Access Compliance Report

Public Rights-of-Way

Intersection ID: 29218	Main Street: ANASTASIA_CT	Cross Street: KORNIV_DR	Location: W
ADA ID: 0A84100FD0C9	Ramp Type: PerpDiag	Initial Pass/Fail: Fail	Overall Compliance: No
		Severity Score: 50

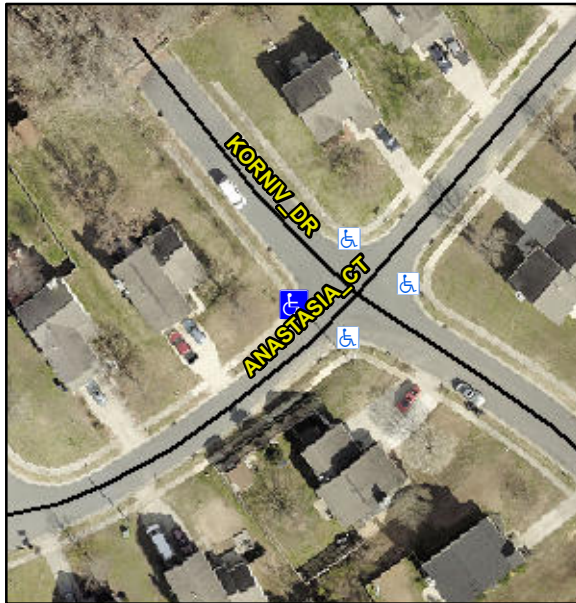
Not Found, R304.2.2, R304.5.3

Compliance	Description	Data	Compliance	Description	Data
N/A	Ramp Length (in)	49.5	No	Ramp Slope (%)	12.6
Yes	Ramp Width (in)	63.0	No	Ramp XSlope (%)	8.4
N/A	Flare Type LT	N/A	N/A	Flare Type RT	N/A
N/A	Flare Slope LT (%)	N/A	N/A	Flare Slope RT (%)	N/A
N/A	Flare Traversable LT?	N/A	N/A	Flare Traversable RT?	N/A
N/A	Landing Length (in)	N/A	N/A	DWS Provided?	N/A
N/A	Landing Width (in)	N/A	N/A	DWS Contrast?	N/A
N/A	Landing Slope (%)	N/A	N/A	DWS Length (in)	N/A
N/A	Landing X Slope (%)	N/A	N/A	DWS Full Width?	N/A
N/A	Landing Curb? (Y/N)	N/A	N/A	DWS Offset (in)	N/A
N/A	Shared Landing?	N/A			
N/A	Gutter Ponding?	N/A	N/A	Gutter Slope (%)	N/A
N/A	Gutter Lip Ht (in)	0.5	N/A	Gutter X Slope (%)	N/A
N/A	Painted X Walk1?	No	N/A	Painted X Walk2?	No
	X Walk 1 Direction	To SE		X Walk 2 Direction	To NE
N/A	X Walk 1 Width (in)	N/A	N/A	X Walk 2 Width (in)	N/A
	X Walk 1 Slope (%)	11.6		X Walk 2 Slope (%)	7.3
	X Walk 1 X Slope (%)	3.8		X Walk 2 X Slope (%)	9.6

Remove & Replace Curb Ramp With Two New Directional Ramps or Equivalent.
